Re: April 30, 2009 Clean Water Act Inspection

NPDES COMPLIANCE EVALUATION INSPECTION

Facility: Satala Power Plant
P.O. Box PPB, Pago Pago, Tutuila Island, American Samoa
(NPDES Permit No. AS0020044)

Date of Inspection: April 30, 2009

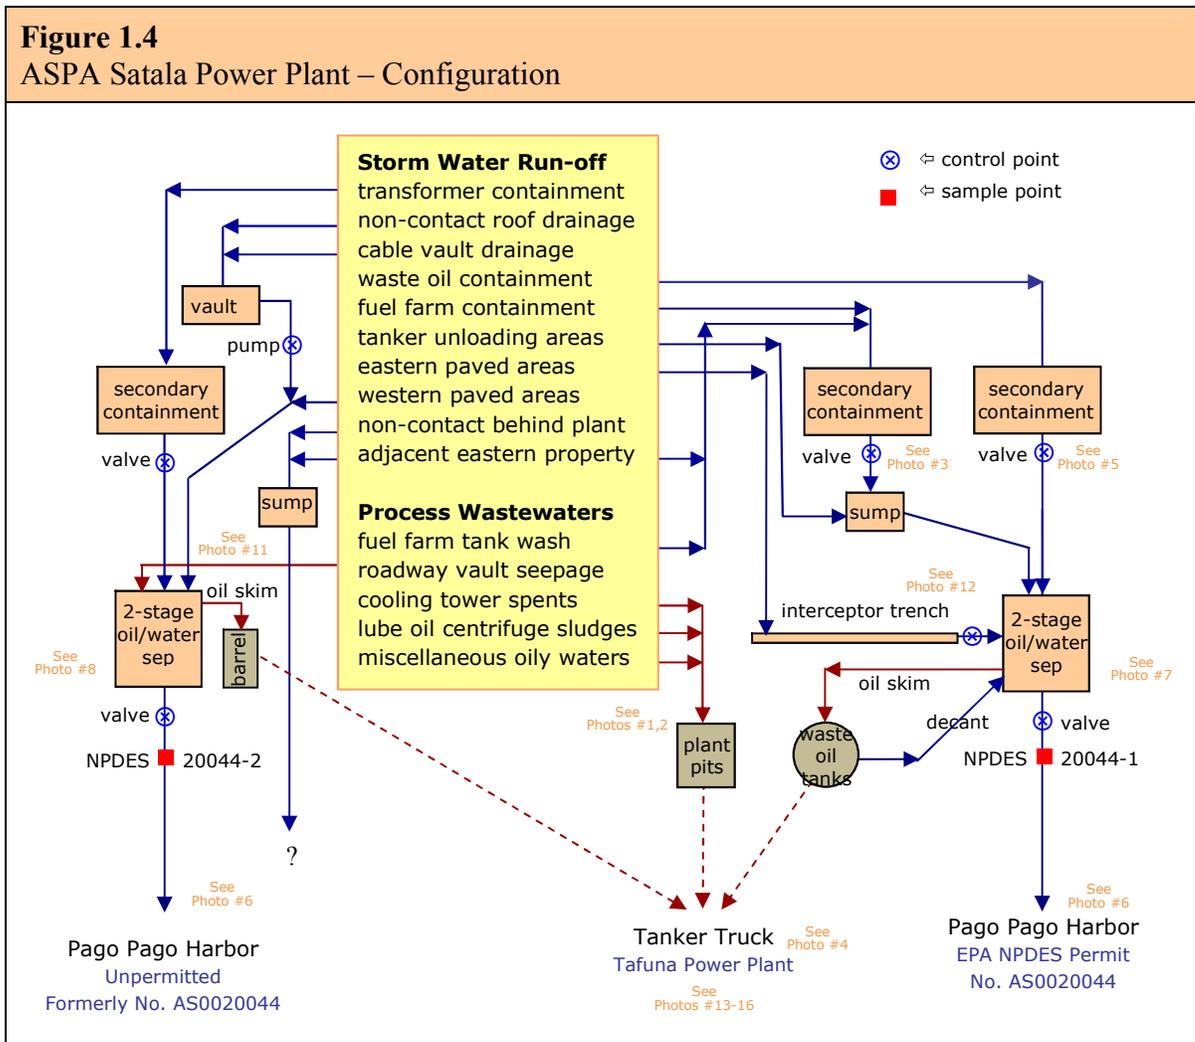
The Satala Power Plant generates oily water power plant drainage, lube oil centrifuge sludges, contact storm water run-off from processing areas, non-contact storm water run-off, fuel tank power washdown, and cooling tower spents. In addition, oily seepages, thought to be the result of historic spills and losses, fill an underground vault in front of Satala Power Plant property and can discharge to the harbor. See Figure 1.4 on the next page.
